COMAL COUNTY

118652.pdf Markup Summary 11-4-2025

Subject: Deficiency
Page Label: 2139 Andalusia Dr.-Layout1
Checkmark: Unchecked
Author: Brandon Mark Olvera
Date: 11/4/2025 9:39:47 AM

Permit Number: 118652
Issued This Date: 06/09/2025
This permit is hereby given to: Jarrett and Meagan Hudek

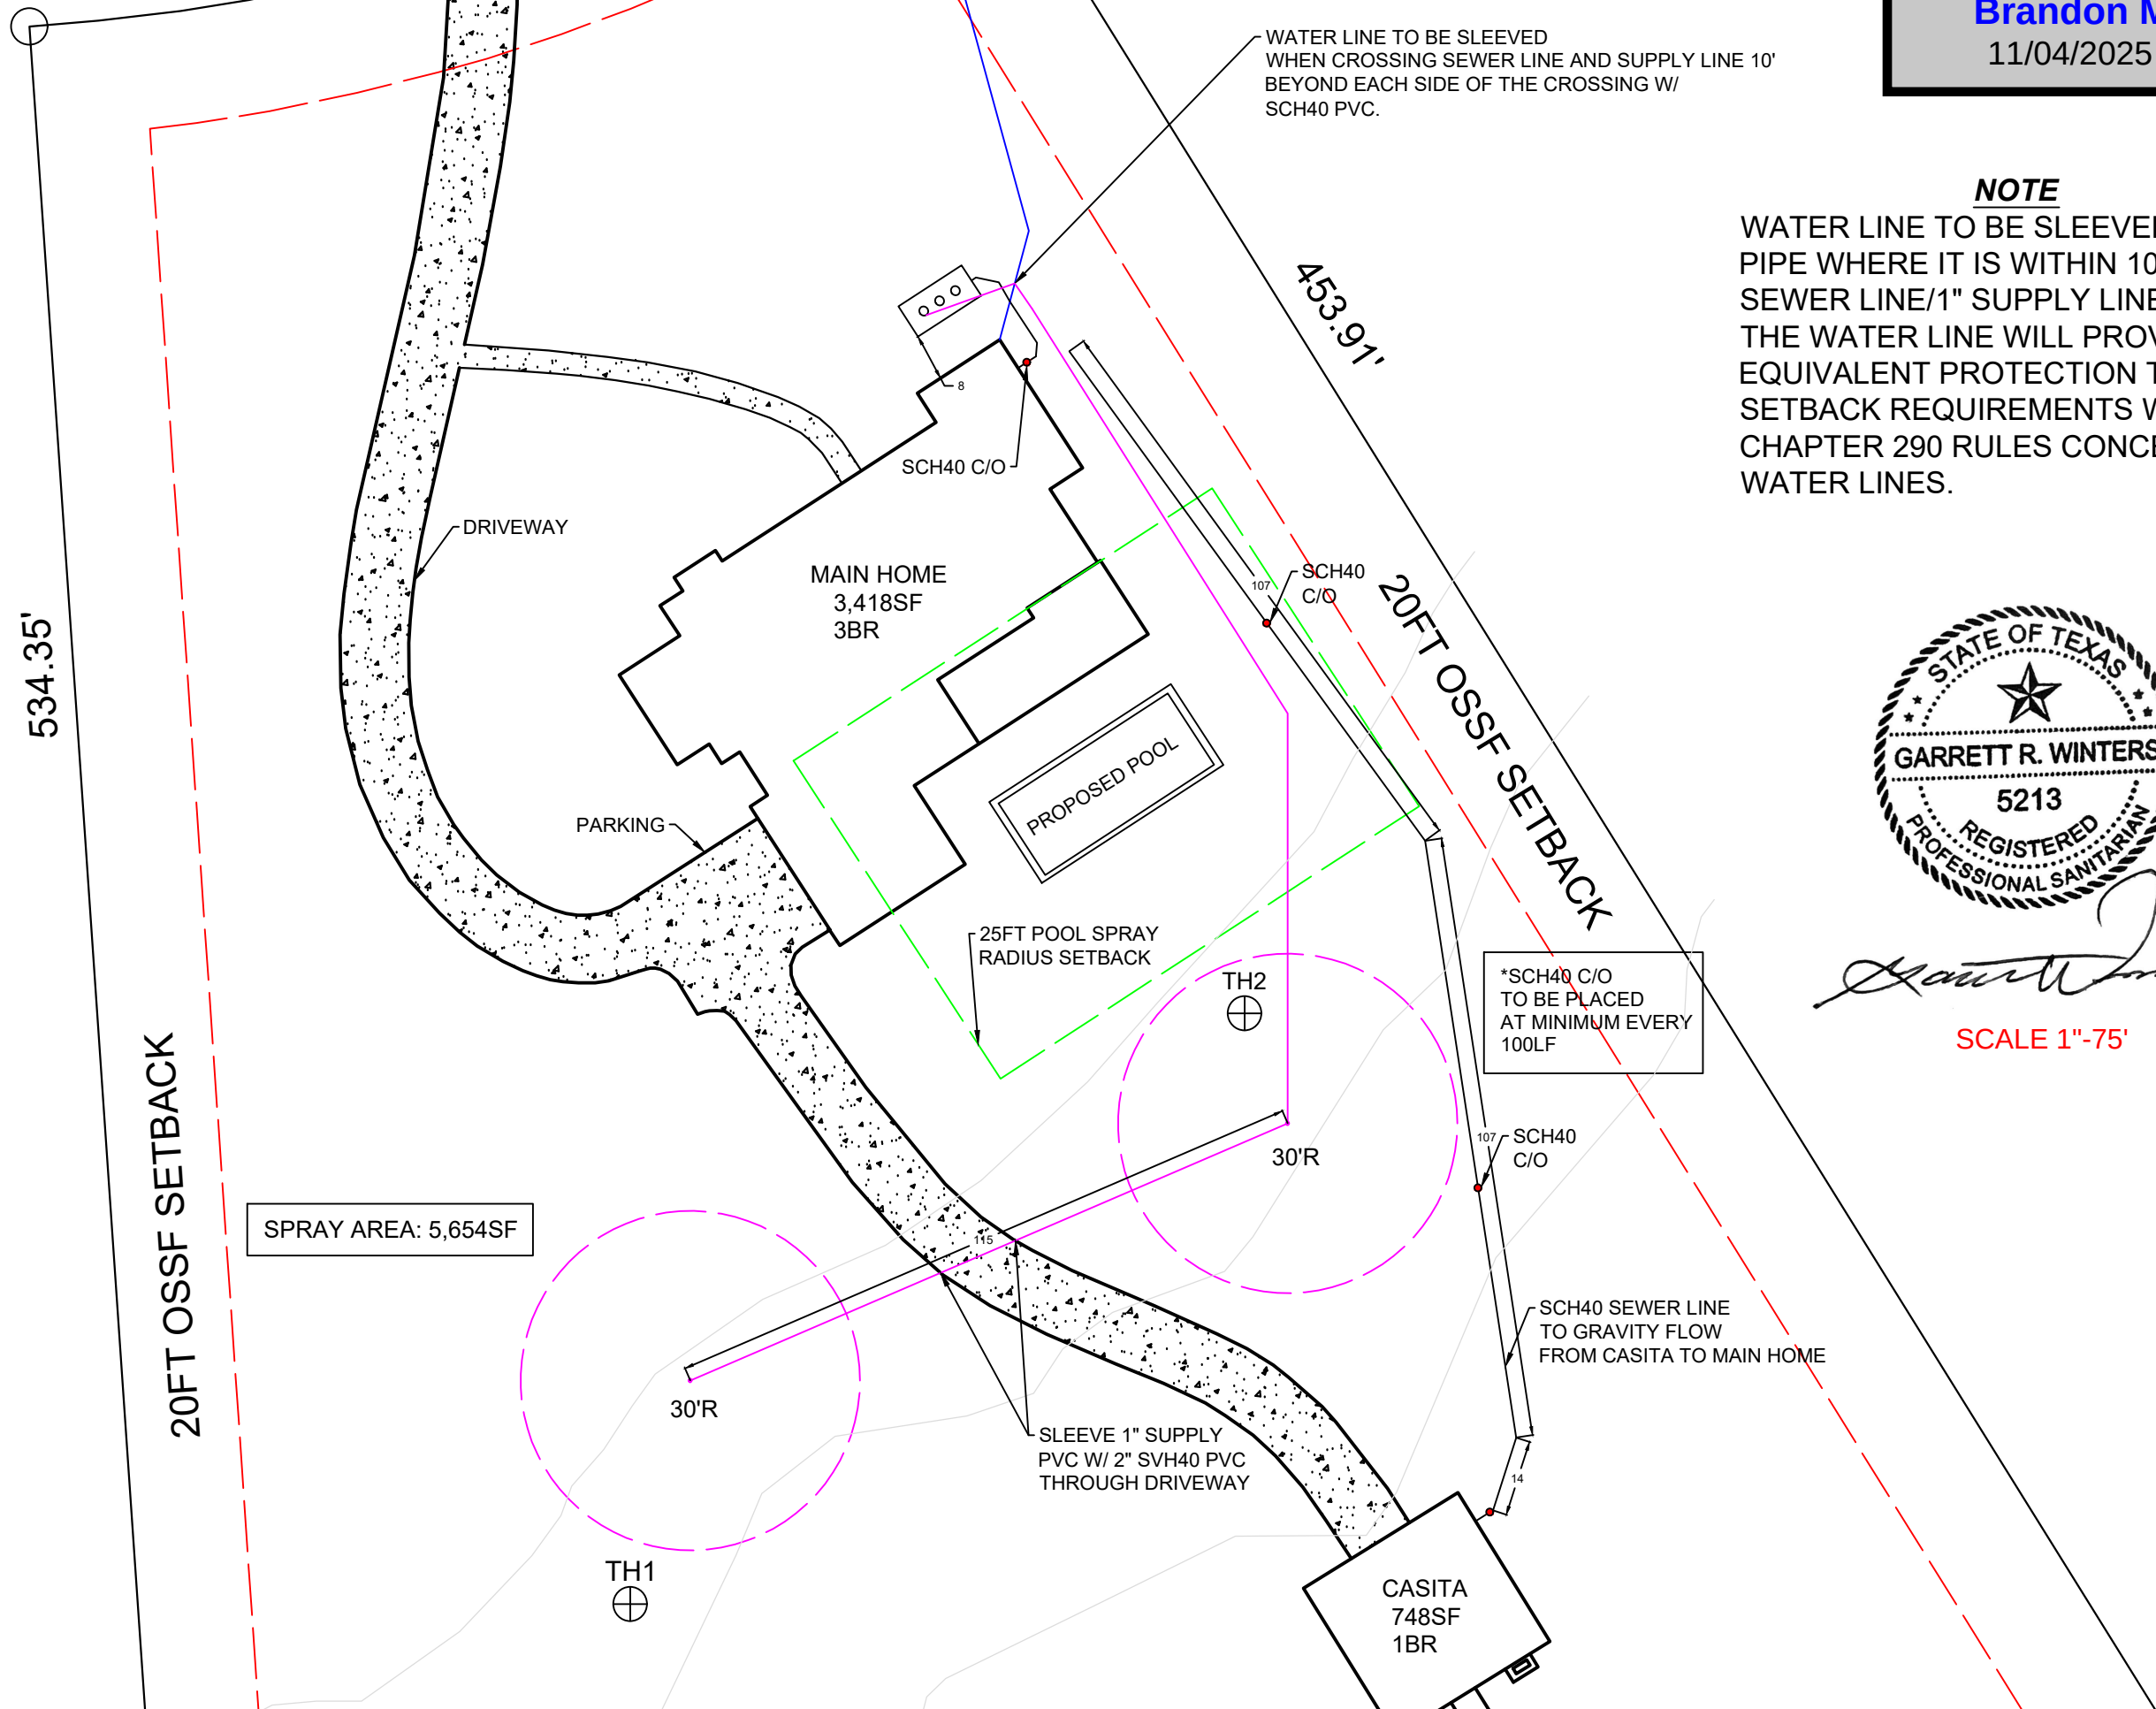
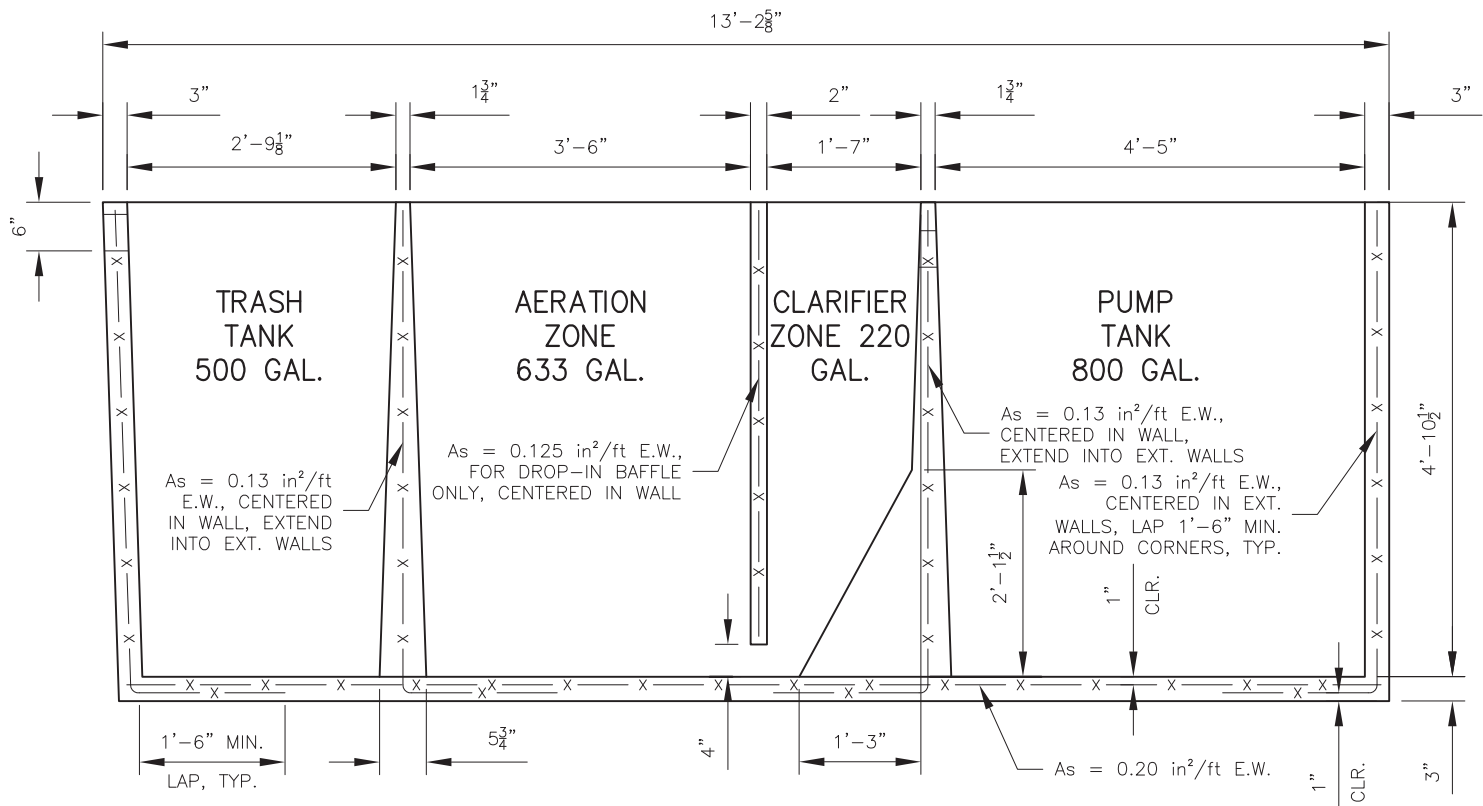
Show the waterline going to the casita on both site plans

I am requesting a variance for one location where the potable water line crosses the sewer line. The water line will be installed inside a Schedule 40 PVC sleeve extending 10 feet beyond the crossing on each side minimum.

NOTE
WATER LINE TO BE SLEEVED IN SCH40 PIPE WHERE IT IS WITHIN 10' OF THE SEWER LINE/1" SUPPLY LINE. SLEEVING THE WATER LINE WILL PROVIDE EQUIVALENT PROTECTION TO THE SETBACK REQUIREMENTS WITH TAC CHAPTER 290 RULES CONCERNING WATER LINES.
